South King Fire and Rescue
Station 66 Facility Improvements

ADDENDUM #2
July 7, 2017

The Bid Documents issued **April 13, 2017** for the project noted above are amended by this Addendum.

N 3 ENLARGED PLAN - 101 LOBBY, 102 WATCH OFFICE, 103 OFFICE, 104 HALL, 105 ADA RR, 106 KITCHEN AND 111 DECON ROOM
1/4" = 1'-0"

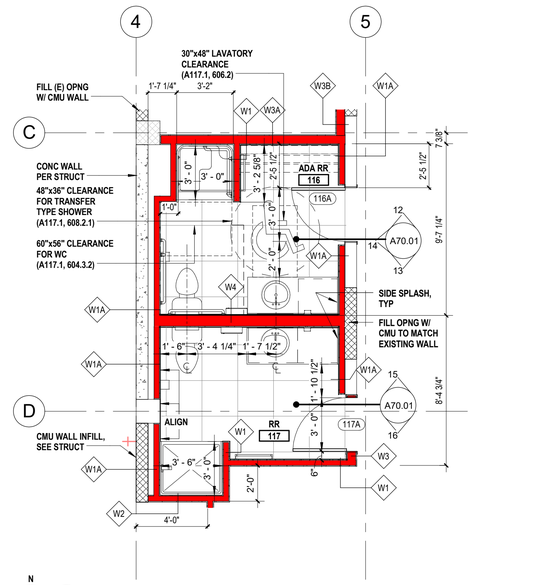
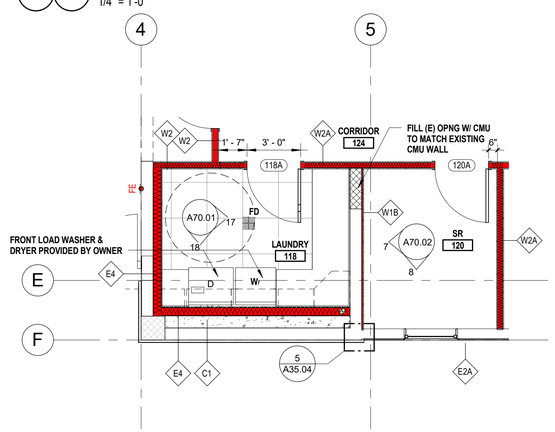
ITEM 3. Revise 106 Kitchen as shown on attached Sheets A26.01 and A70.01.
